Paso Basin Cooperative Committee Notice of Regular Meeting

March 27, 2024

Agenda Item #7 – Report on SGMA GSP Round 1 Grant Implementation

Figure 1: Locations of interconnection between groundwater and surface water.

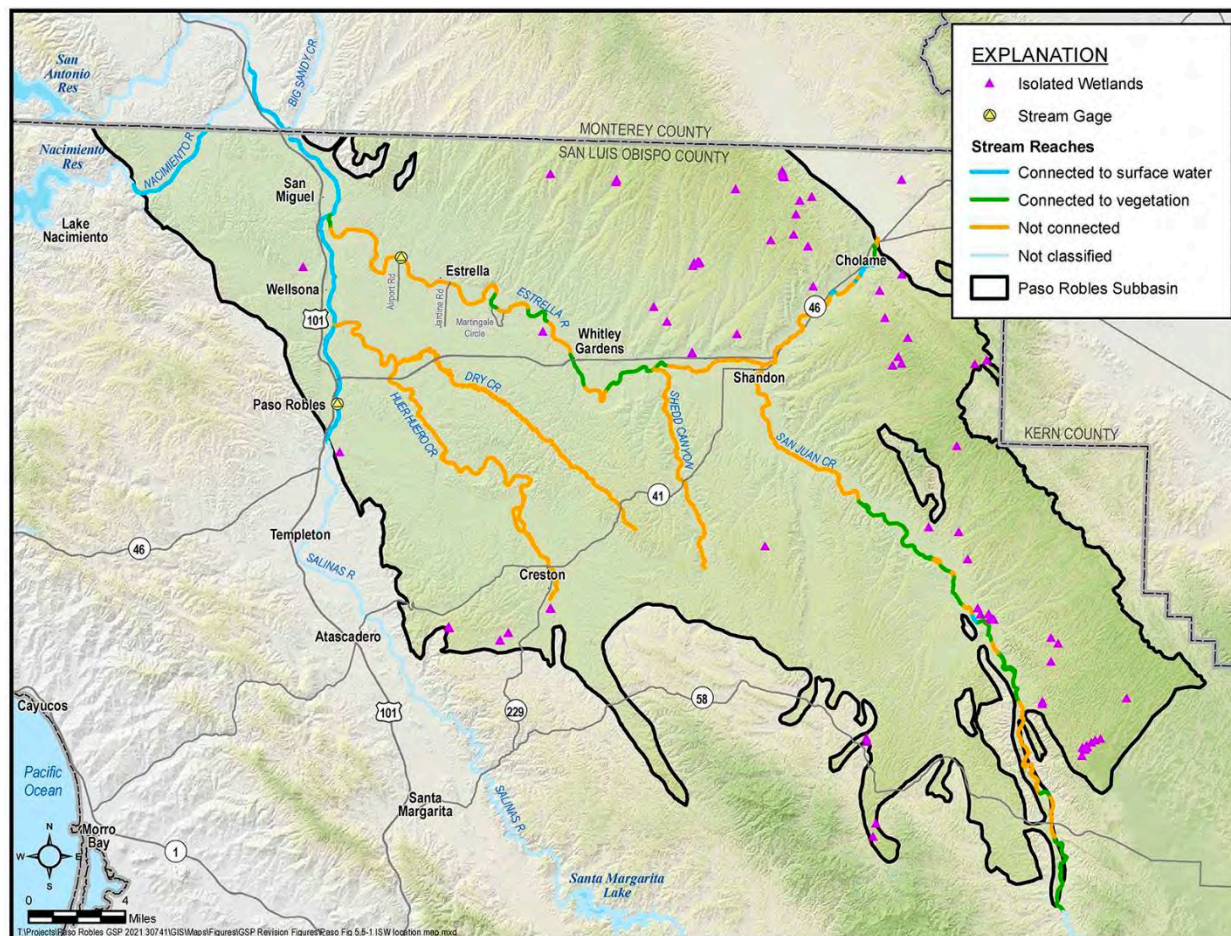
Staff consider the revised Plan to be generally improved but still missing information that should be included to improve clarity and completeness in addressing the GSP Regulations and facilitate staff evaluations of GSP and subsequent periodic evaluations. The Plan notes that pumping from the Alluvial Aquifer is “rare”, generally occurs to meet domestic and limited livestock water demands, and large-scale irrigation pumping does not typically occur.⁵¹ However, the GSP also states that the agricultural water use sector—which is the largest by volume⁵² with production wells located along the Salinas and Estrella Rivers⁵³—also pumps from the Alluvial Aquifer⁵⁴ without quantifying that volume. The GSP should provide specific volumetric quantities of estimated pumping that

FIGURE 10
Communities Dependent on Groundwater and with Access to Surface Water
Paso Robles Subbasin
Water Year 2023 Annual Report

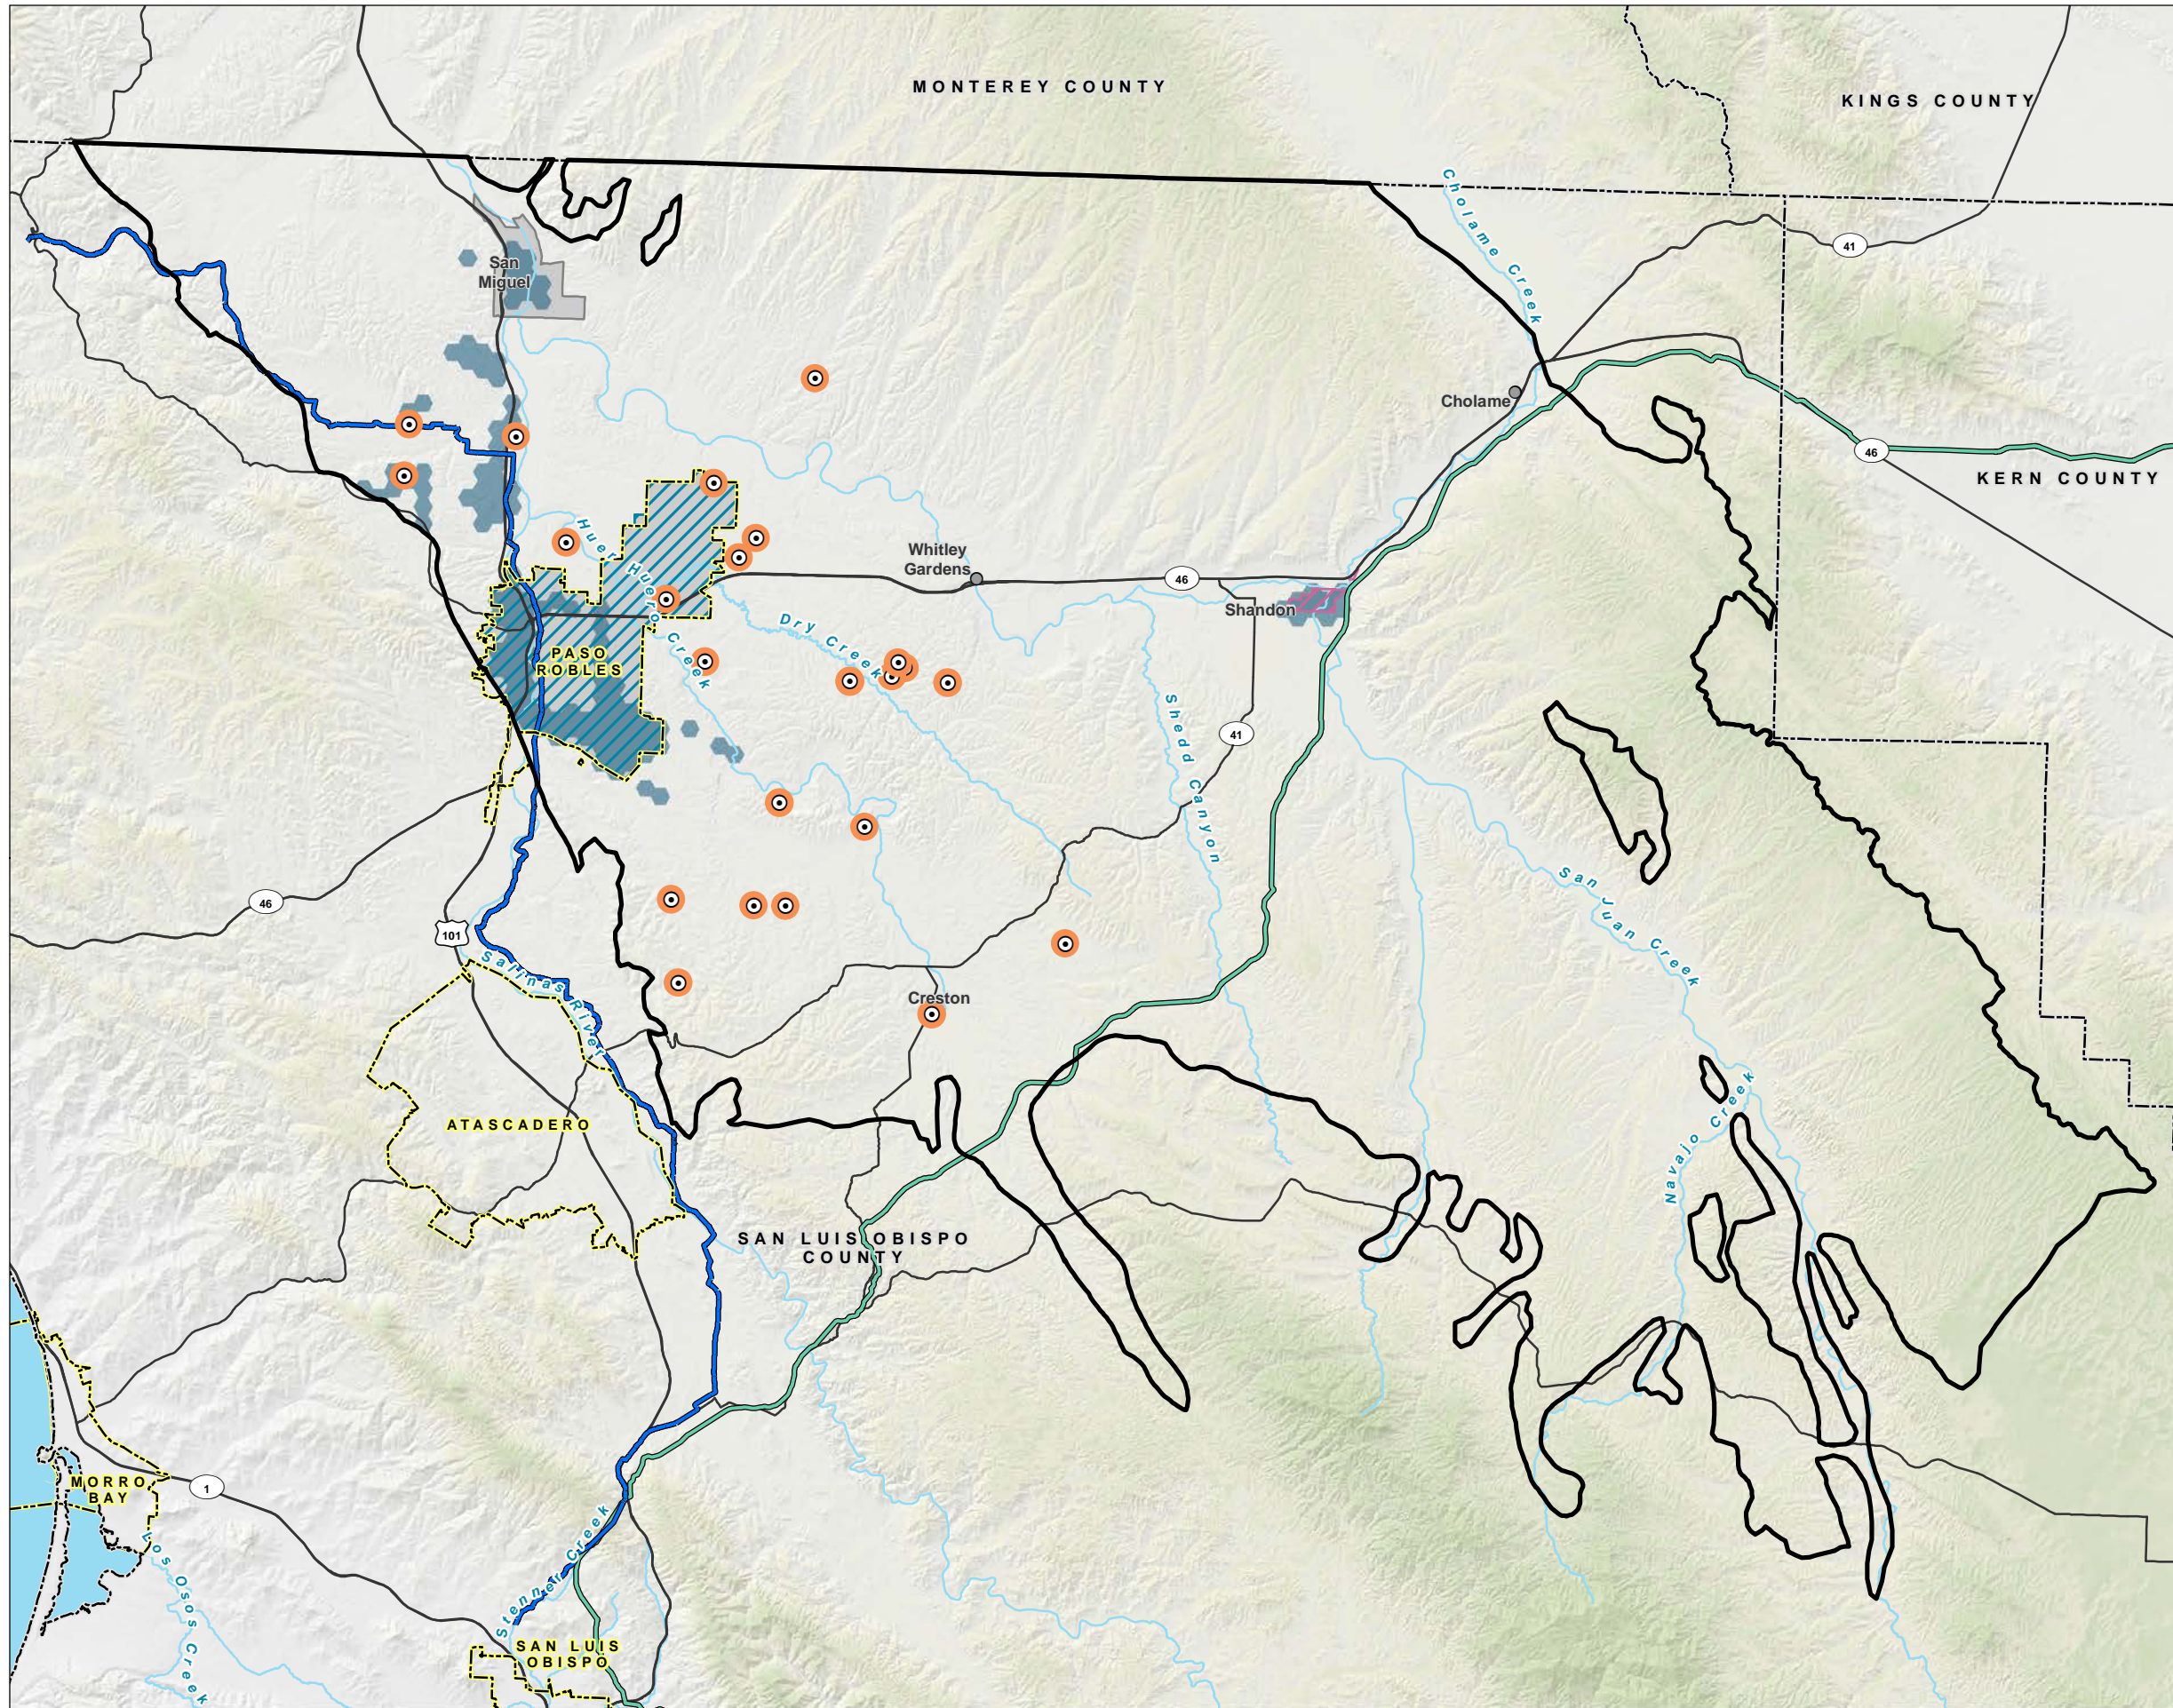
Greg Grewal	n/a	n/a	“Report shows no information on the Naci pipeline repairs, problems, and reduced capacity.”	All Nacimiento Pipeline problems in WY 2023 were downstream from Subbasin entitlement holders (City of Paso Robles). No changes made.
Greg Grewal	Sec. 8.5.3	Page 56	“Salinas River. Water going to SLO causing reduced recharge of the interconnectivity of surface water to ground water.”	Comment noted. Existing water rights are regulated by the SWRCB. No changes made.
Greg Grewal	Sec. 4.3	Figure 8	“Irrigated Ag.- should also show Ag. Pond locations and circles of the Ag.cluster homes with shallow well issues in and amongst the irrigated Ag.”	The locations of the Ag ponds have been added to Figure 8. The locations of reported dry wells for WY 2023 are already included on Figure 10.
